### ***Justification for Removing TEST\_MODE***

*TEST\_MODE is out of scope of this power standard and is best left for proprietary implementation.*

Figure 145–13—Top level PSE state diagram (continued)

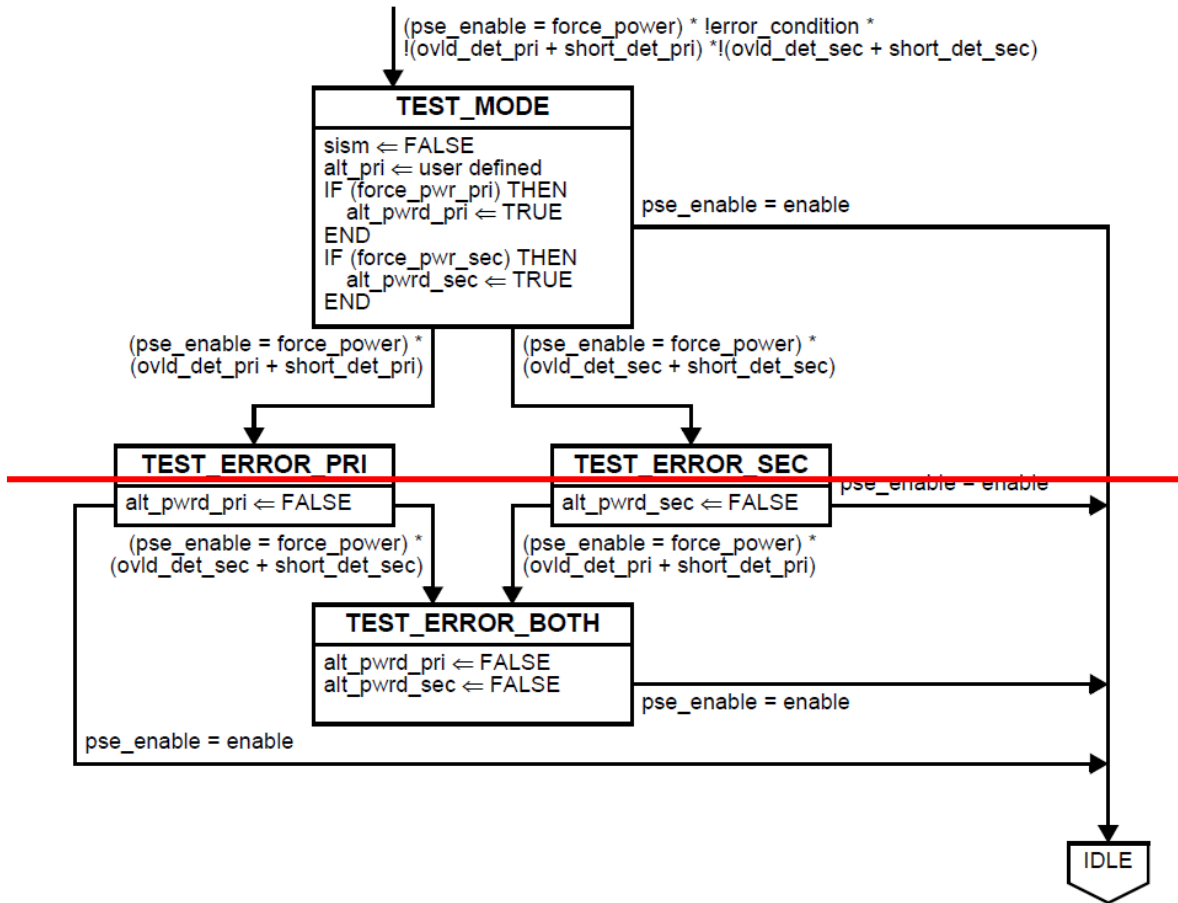
### 145.2.5.7

Remove entire TEST\_MODE page

Editor to be granted editorial license to remove references to test modes either in the current draft or draft 3.0 comment resolutions.
